THE HYDROGEOLOGIC INTEGRITY OF THE THE SAND DRAW SAN#1
LANDFILL, FREMONT COUNTY, WYOMING

Donald I. Siegel PhD
Hydrogeologist.

RE: Permit renewal and major amendment application (April 30, 2005)
Sand Draw Landfill
SHWD File # 10.195

Figure 1. Geologic map of the Sand Draw San #1 landfill

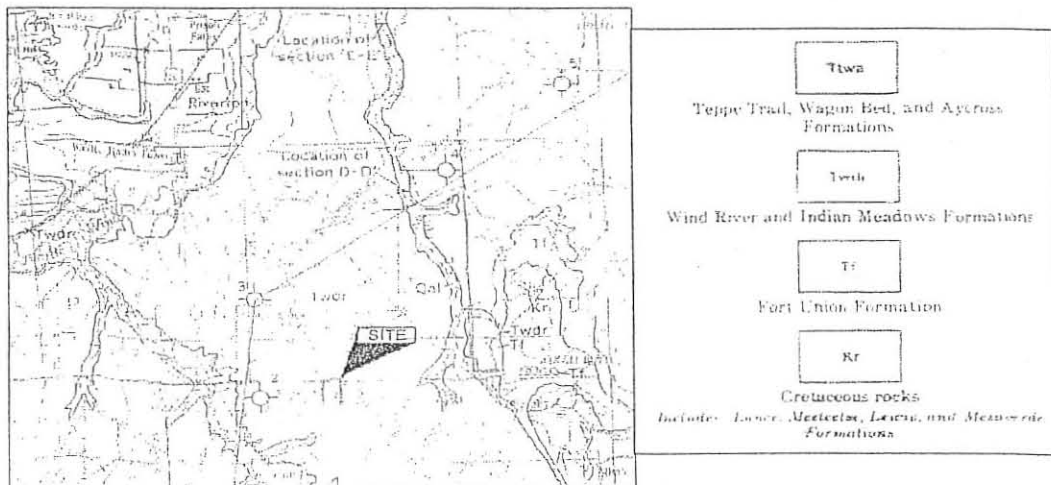
The Sand Draw San #1 landfill is located southeast of Riverton (WY) on laterally discontinuous claystones, siltstones, and dense sandstones. These all are units within the Tertiary age Wind River and Indian Meadows geologic formations (Fig. 1). Produccable water in these formations is commonly hundreds of feet deep (Whitcomb, H.A. and Lowry, M. E.,1968).
